**PROPOSED SOCIAL WELFARE FACILITY (RESIDENTIAL CARE HOME FOR THE ELDERLY) IN
“VILLAGE TYPE DEVELOPMENT” ZONE ON APPROVED NAM SANG WAI OUTLINE ZONING
PLAN NO. S/YL-NSW/10 AT LOTS 3670 RP (PART), 3671 RP (PART), 3672 RP (PART) AND 3673
RP (PART) IN D.D.104, NAM SANG WAI, YUEN LONG**

Town Planning Application No. A/YL-NSW/349 - Submission of Further Information (3)

Response-to-Comment Table

**FIGURE 2.1
LOCATION OF REPRESENTATIVE AIR
SENSITIVE RECEIVERS**

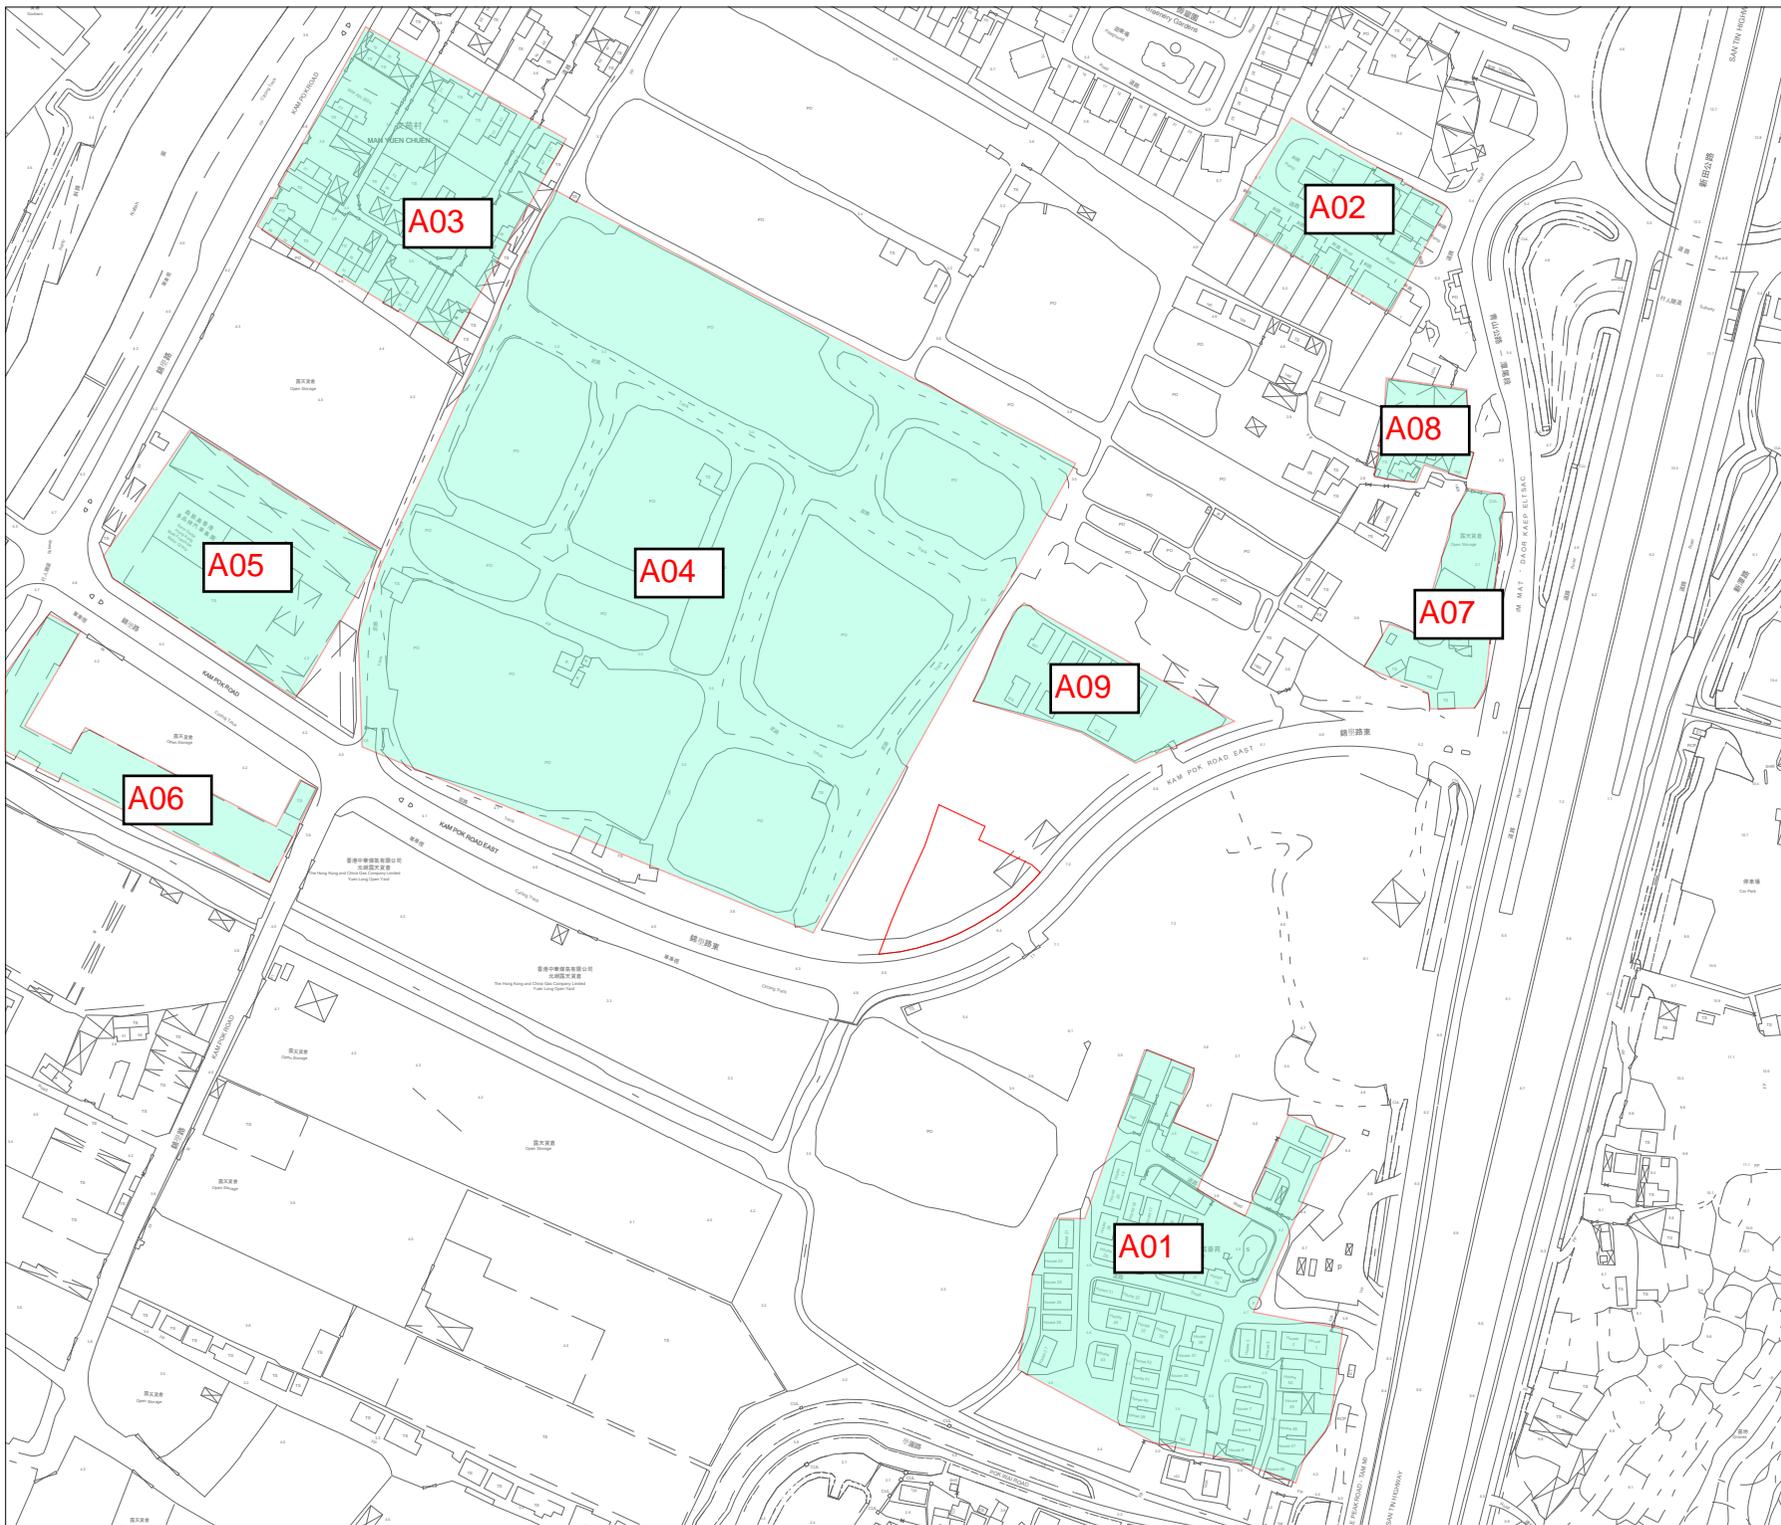
| 2. S.2.3.1, Table 2.3 and Figure 2.1 – it is noted that there are some structures to the north and to the southeast of the site as shown below. Please review if these structures are considered as ASRs. | New ASR was added for structures to the north of the site. Structures to the southeast of the site should be incorporated in A01. The corresponding Section, Table and Figure are updated accordingly. |

| Email dated 27th June 2025 refers: | |
|---|--|
| 3. Section 2.3.1, Table 2.3 and Figure 2.1 - Please note that not only the domestic premises are the ASRs, some places/premises such as factory and workshop may also be the ASRs. Based on the desktop review, there are some areas in the vicinity of the project site which have been used for workshops/open storage, etc. Please review the potential existing/planned ASRs within the assessment area with reference to the Determination of ASR under the EIAO-TM and update as appropriate. | More ASRs have been identified in Table 2.3 and Figure 2.1. For other areas mainly for open storage use where long duration of exposure to air pollutants is not expected are, therefore, not considered as ASR. |

**FIGURE 3.3
LOCATION OF PROPOSED ACOUSTIC
WINDOW**

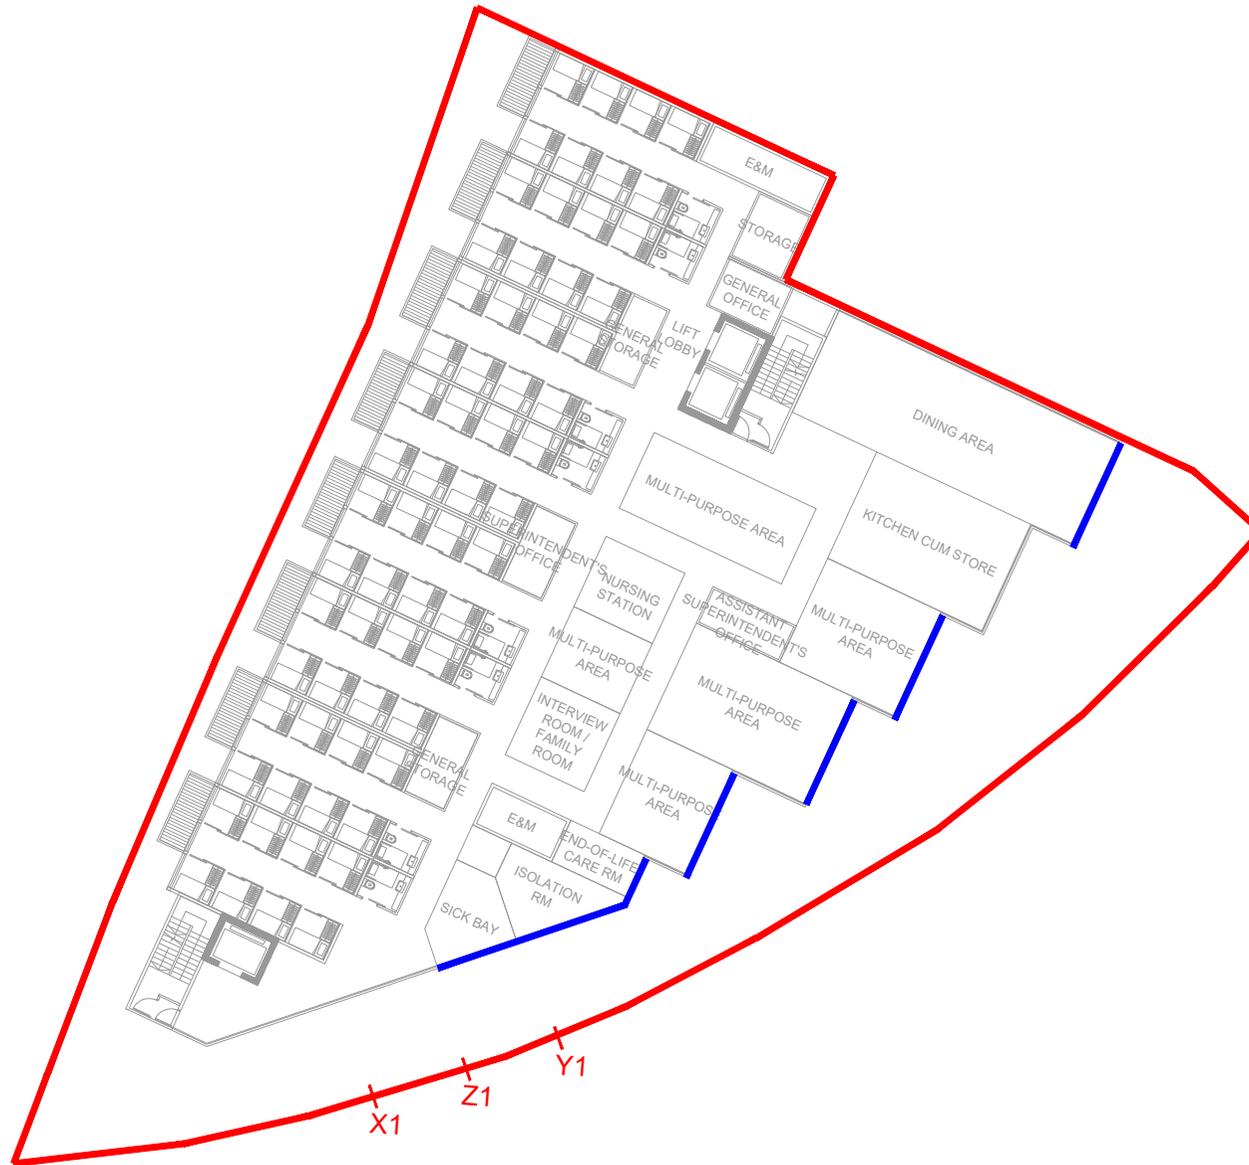
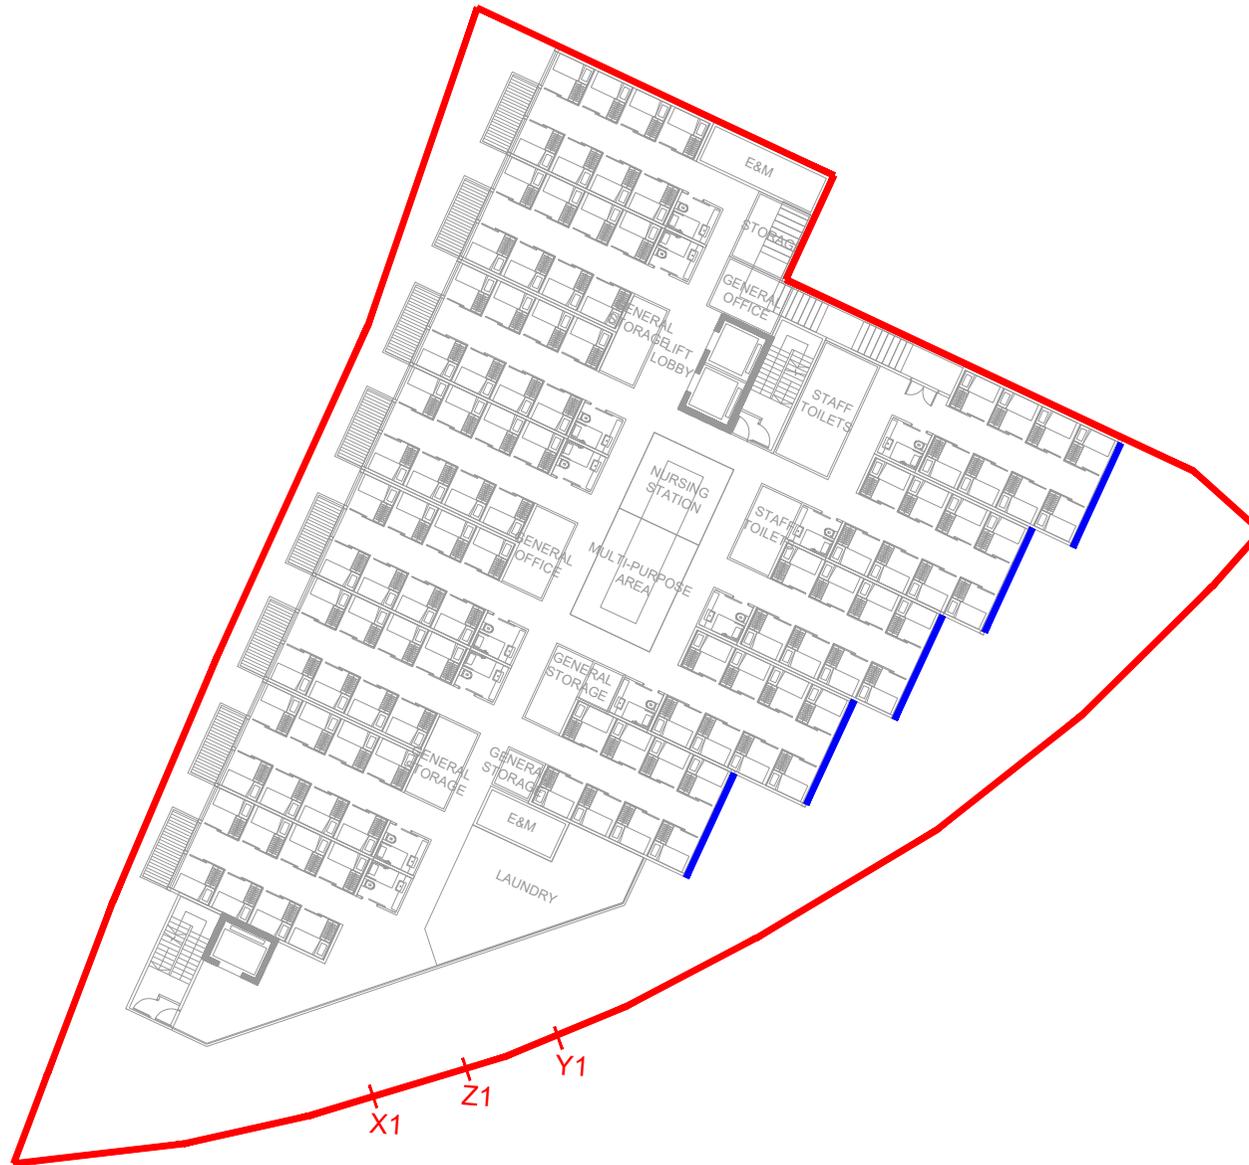
| <p>9. S.3.4.12 and Fig.3.3, Appendix 3.2 i. As shown on Fig 3.3, the reference case for Type 2 AW(BT) is under room size of 18 m² with a specified window design, providing a noise attenuation of 7 dB(A). S.3.4.12 also suggests that noise reduction depends on room size. While Appendix 3.2 proposes the use of Type 2 AW(BT) at 21 NAPs, please provide the room size in the tentative layout and any room size correction, justifying a noise attenuation of 7 dB(A) by Type 2 AW(BT) are appropriate.</p> | <p>Please be clarified that the room size of dormitory is typically 40 to 50 m², which is larger than 18 m², therefore, no room size correction is included for conservative approach.</p> |
| <p>11. S.3.4.18 and Table 3.7 i. Figure 3.3 is Location of Proposed Acoustic Window. Please update</p> | <p>Location of existing major noise sources and site inspection record are</p> |

FIGURE 3.4
LOCATION OF BACKGROUND NOISE
MEASUREMENT AND MAJOR FIXED NOISE
SOURCES

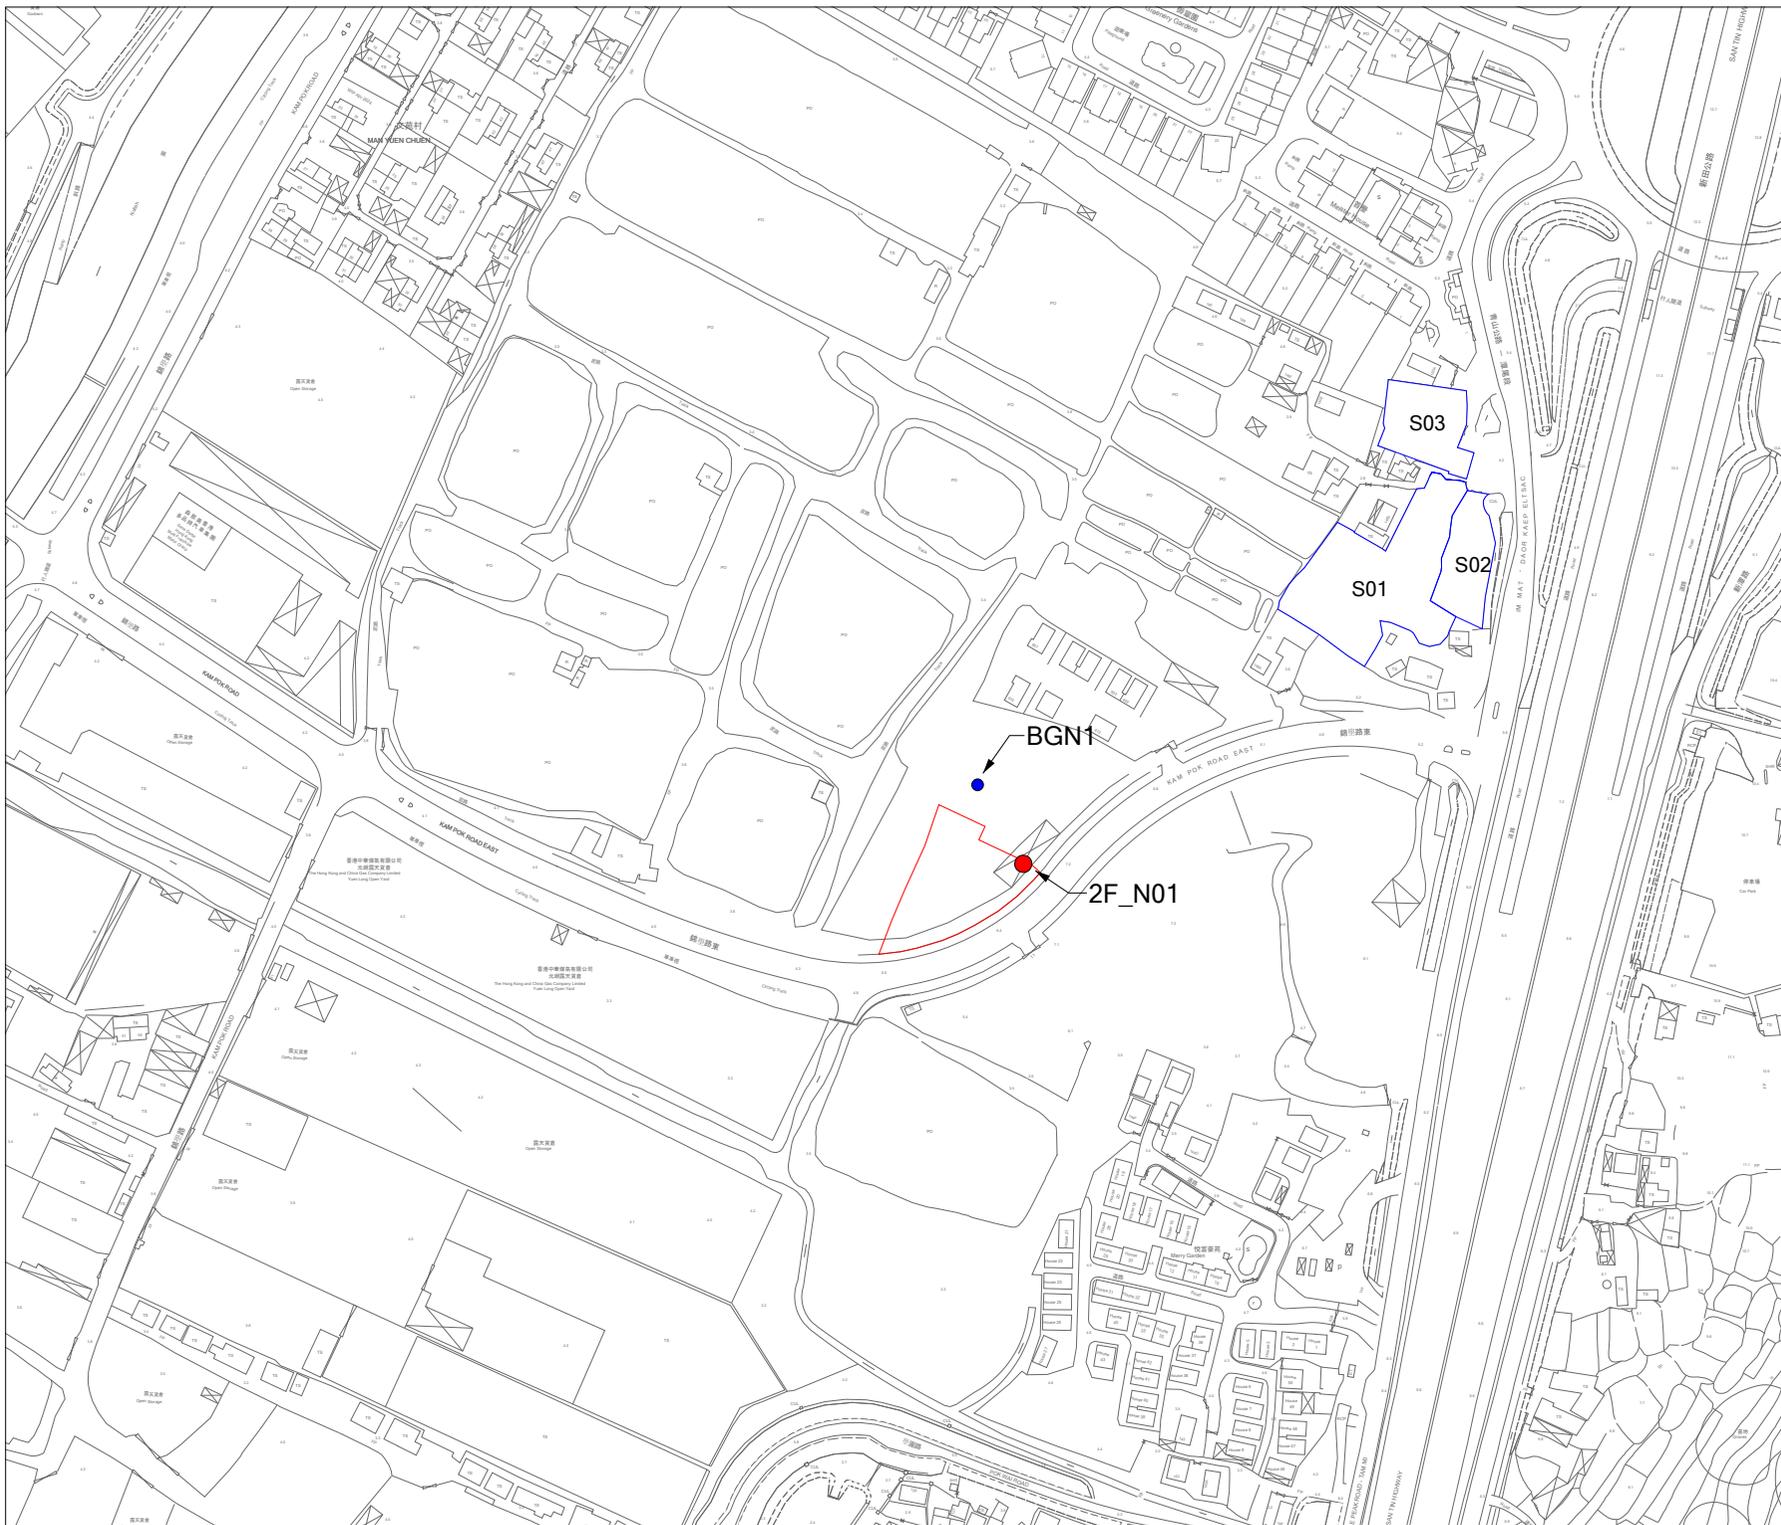
| <p>7. Appendix 3.4 and fig 3.4 , S3.4.23</p> <p>i. There is a fixed noise assessment point located at 2F_N01, as indicated in Appendix 3.4. Please include the corresponding fixed noise assessment point in Figure 3.4.</p> <p>ii. Additionally, in the main text section S3.4.23 or any where appropriate, please provide an explanation for the selection of this fixed noise assessment point. It should be clarified if this point was chosen due to it being the most affected direction / the shortest distance to the noise sources.</p> <p>iii. Please also provide the calculation excel sheet for our checking.</p> | <p>The Figure is updated accordingly.</p> <p>The explanation is provided in S3.4.23.</p> <p>Noted.</p> |
